RE: Existing Septic System Inspection HTE# 14-5-33468

An attempt was made to evaluate your property for the purpose of issuing an Existing Tank Permit. The evaluation could not be completed for one or more of the following reasons.

PLOT PLAN

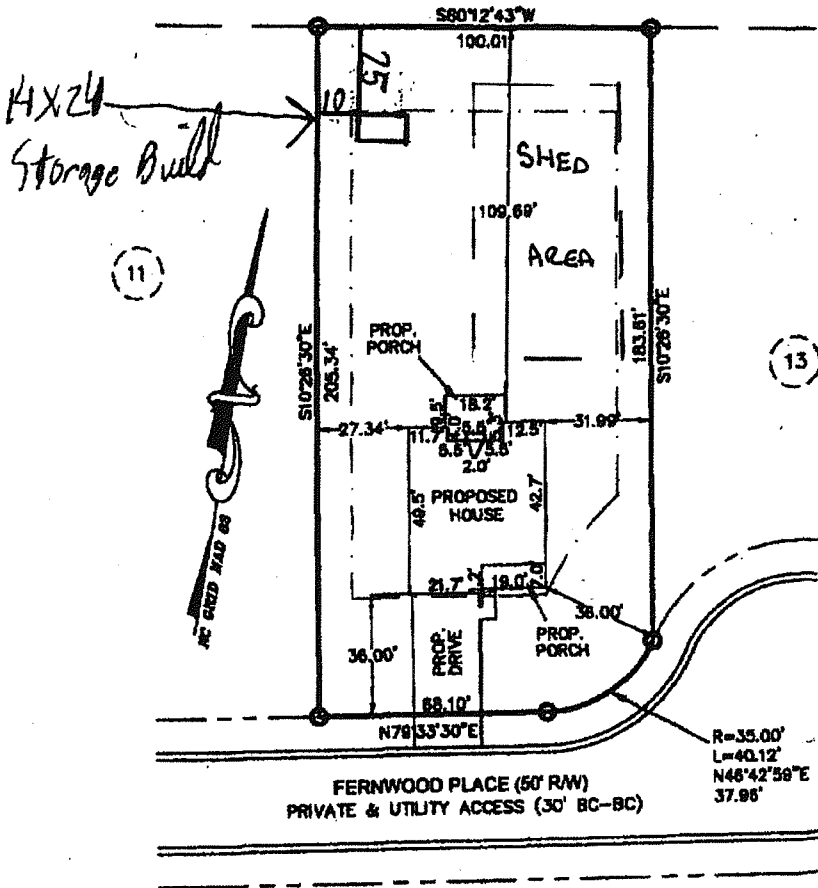
- 1. Uncover outlet lid on septic tank and break seal (**\$25.00 fee incurred**)
- 2. Have system pumped out
- 3. Replace sanitary T
- 4. Other – Shed must be moved out of initial drain field area, see the attached drawing.**
